Draft EIR Comments and Responses

Appendix I
Chevron Carpinteria Oil and Gas Facility Decommissioning Project
Final Environmental Impact Report
Draft EIR Responses to Comments

**TREE MAINTENANCE
INVENTORY MAP**

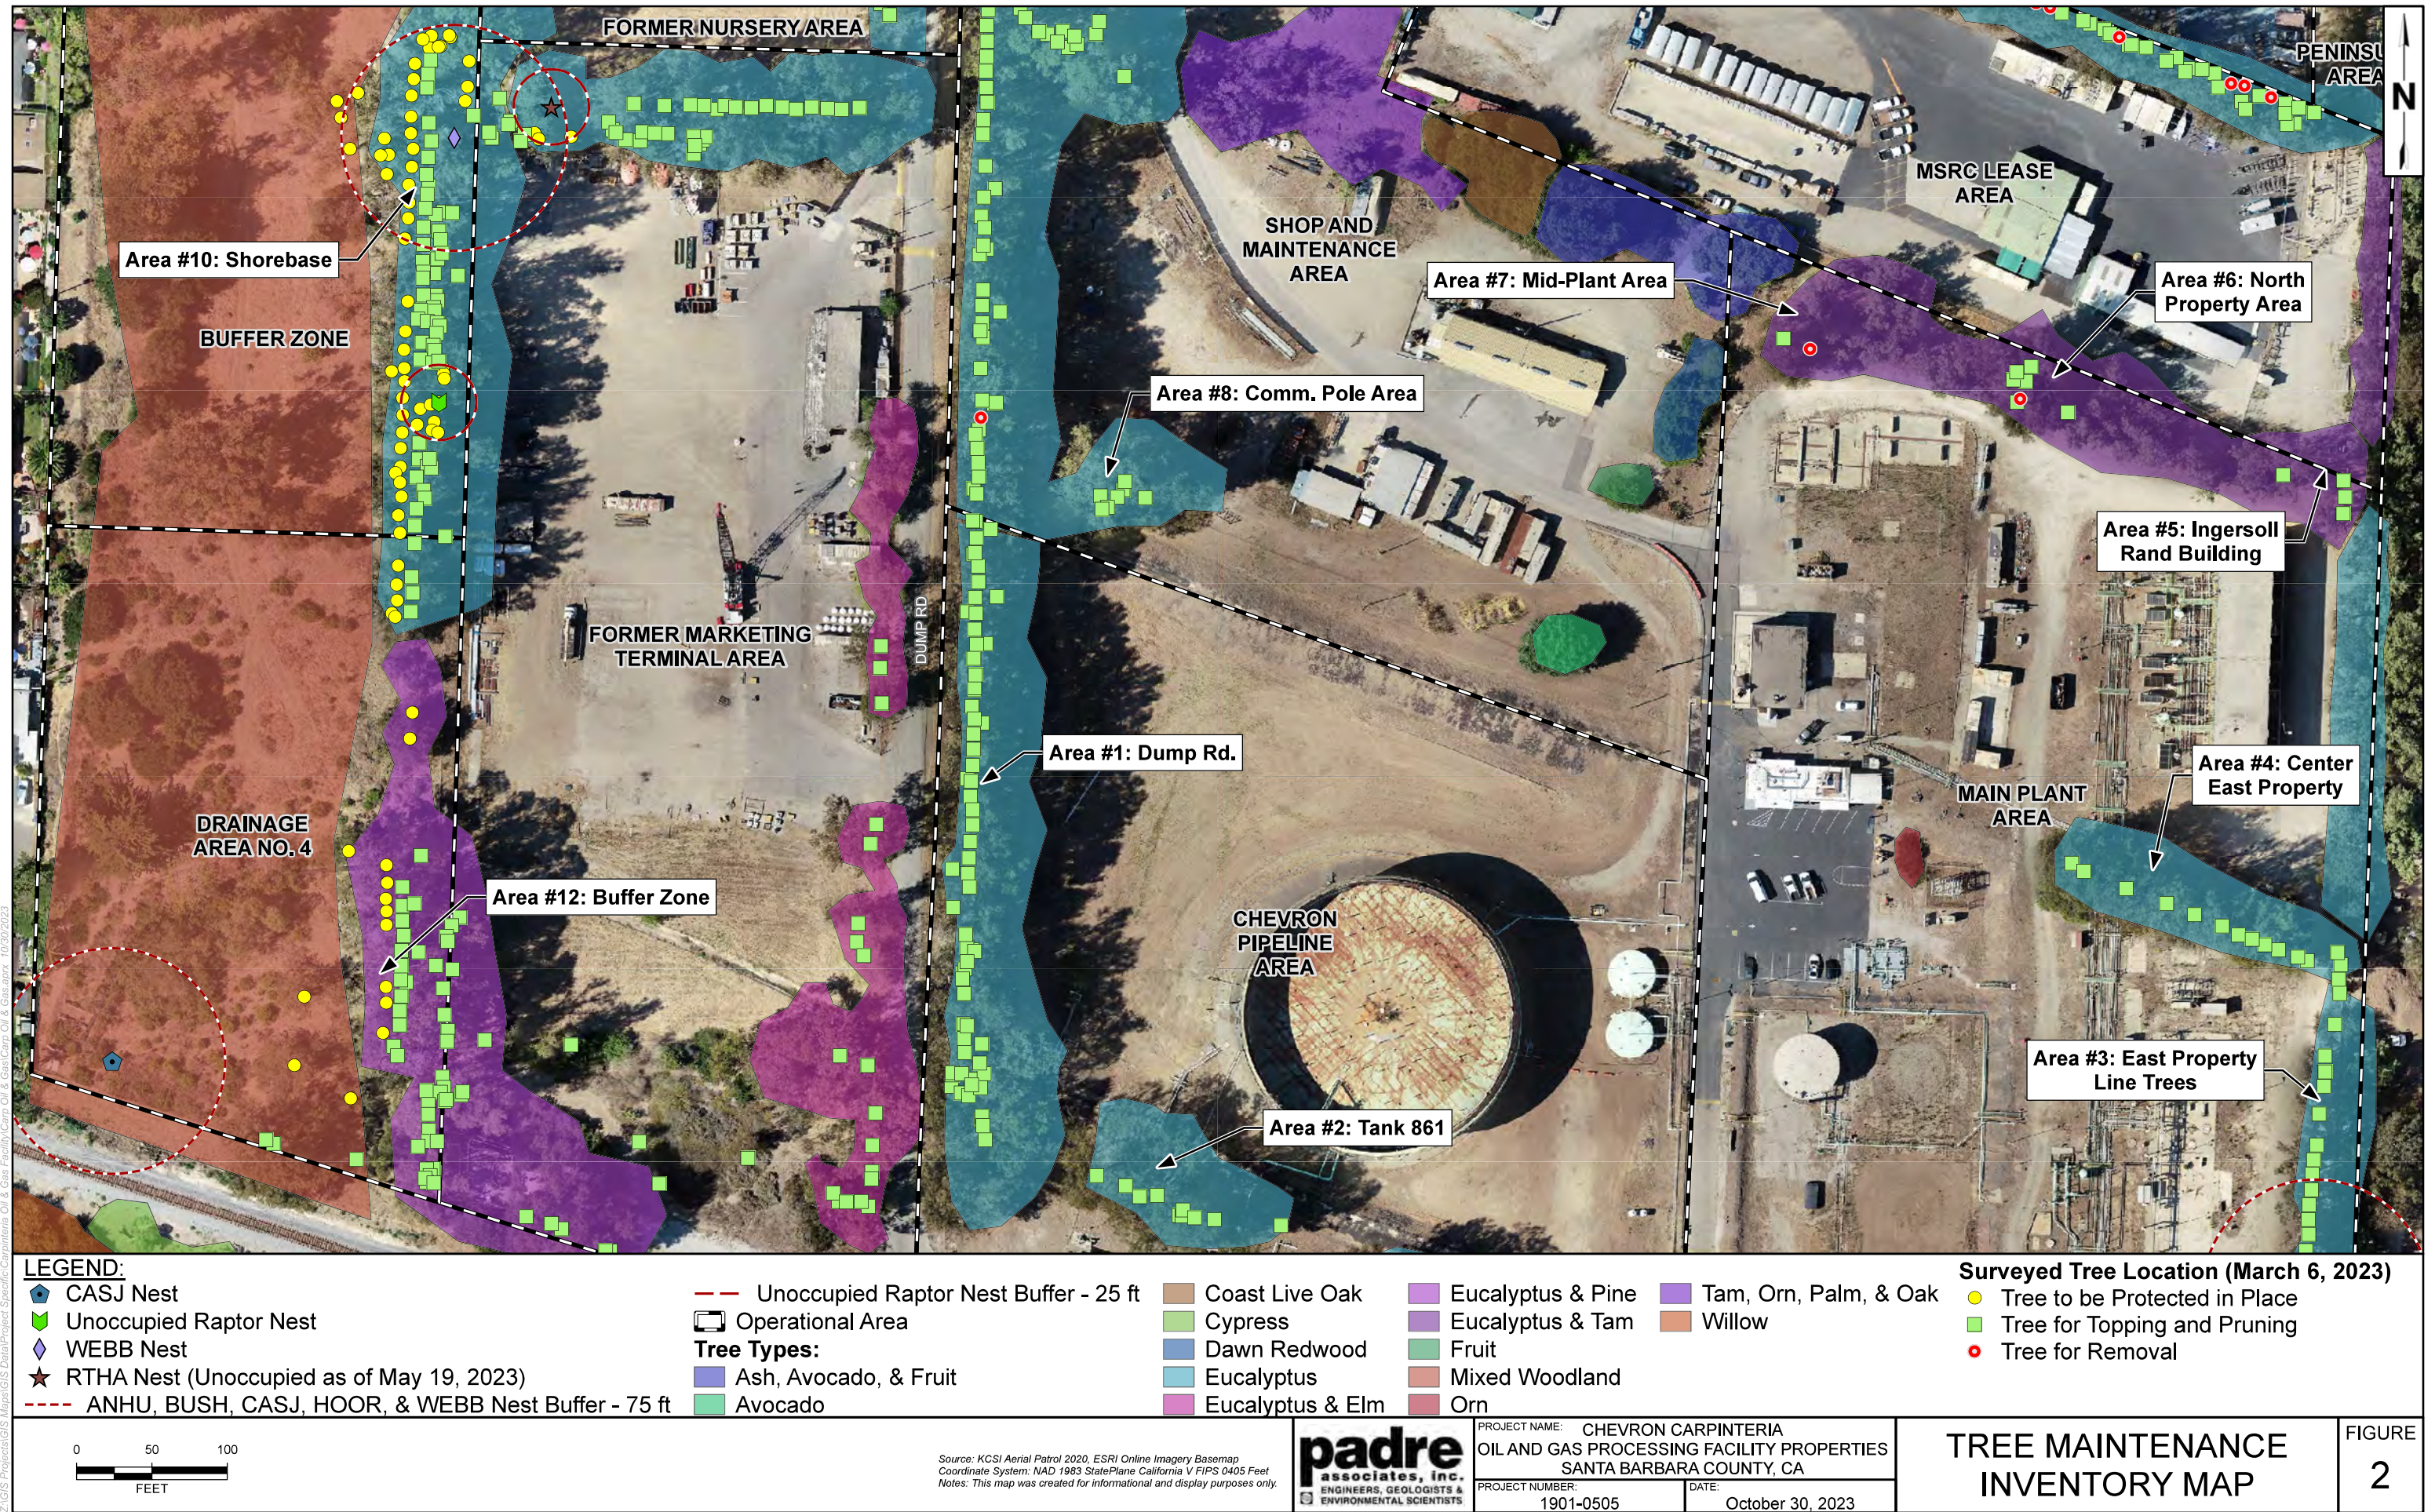
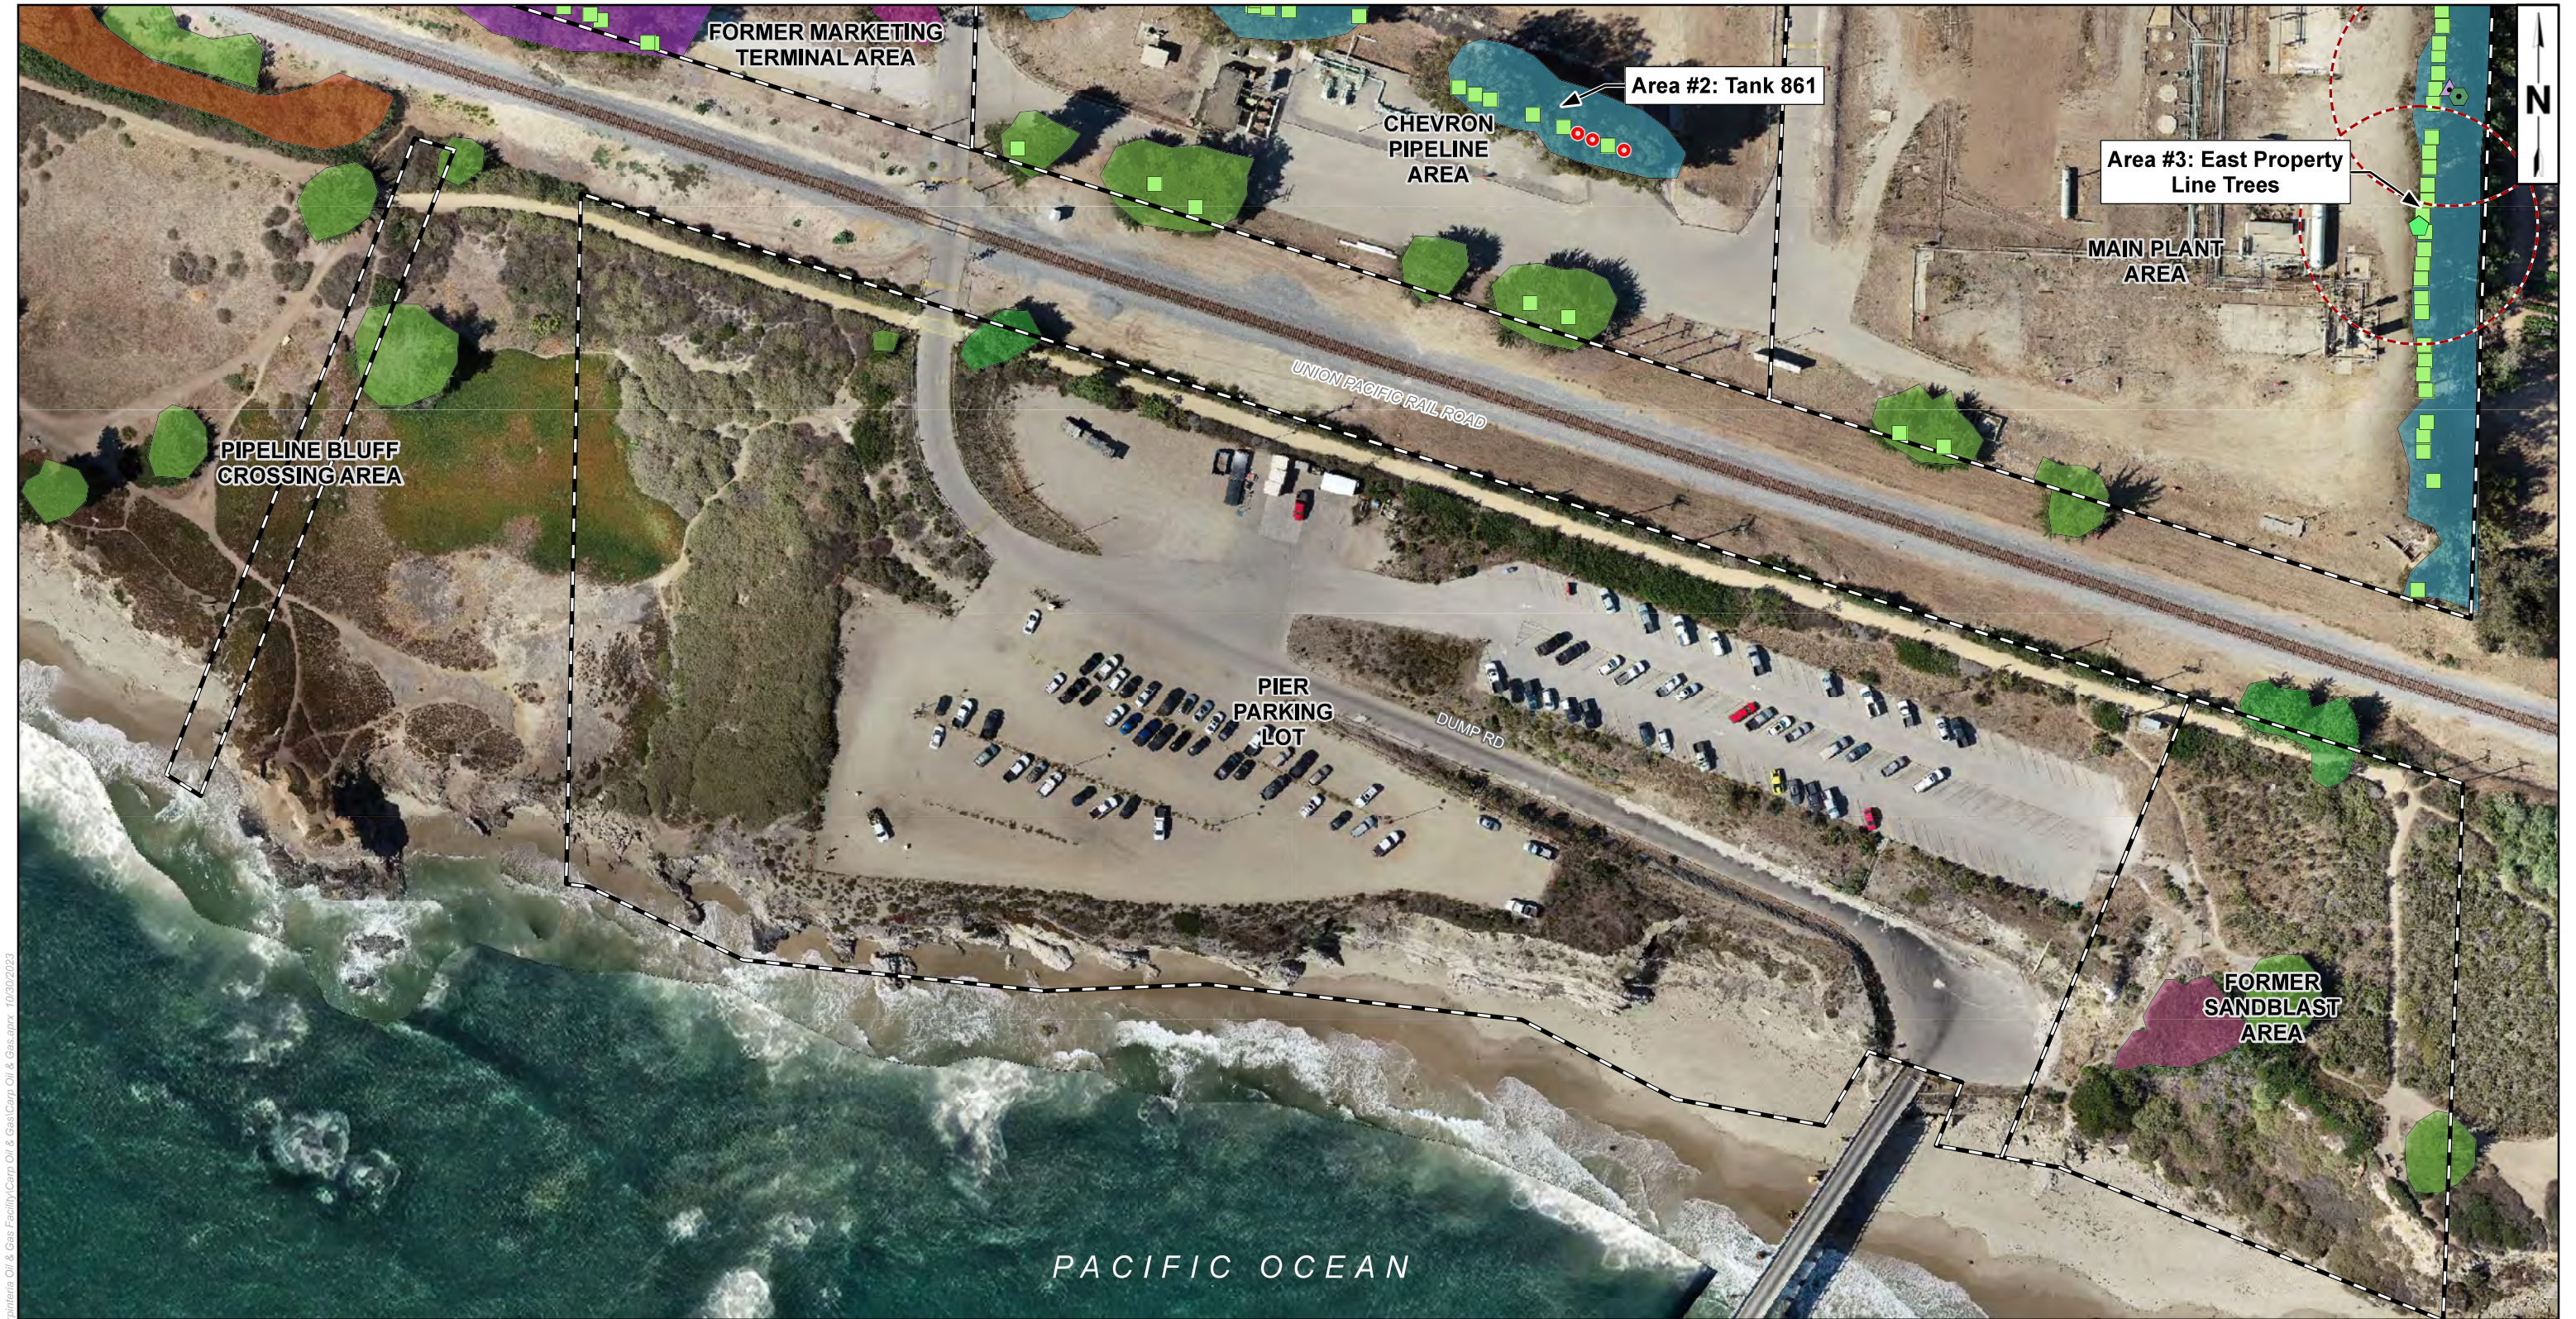
BR-12	4.3.4	4.3-61	Bio.1.h – Consistent with Bio.1c, we suggest revising to refer to a "qualified City-approved wildlife biologist"; see Comment BR-10 above.
BR-13	4.3.4	4.3-65	To avoid confusion, Mitigation Measure Bio.3.c, requiring compensatory wetland mitigation, should be revised to clarify that the compensatory wetland replacement shall not occur in any area (e.g., the buffer zone) which will be revegetated with other vegetation under MM Bio.1.b.9.
BR-14	4.3.4	4.3-68	Figure 4.3-10, Tree Inventory Map. The Figure provided shows close, but not exact locations of trees, and the figure cuts off the southernmost portion of trees slated for removal. For the record, a more accurate inventory map is attached as Attachment 4 to these comments.

BR-12	See Response to Comment BR-10.
BR-13	The mitigation measure has been edited as suggested in the comment.
BR-14	The Tree Inventory Map with updated version has been replaced.
CR-1	Page 6-14 of the Cultural Resources Appendix specifically states contrary to the comment that: "Although the records search results indicated that no previously recorded cultural resources are located within the Former Sandblast Area, the mapped boundary of CA-SBA-6 encompasses adjoining areas to the immediate east and
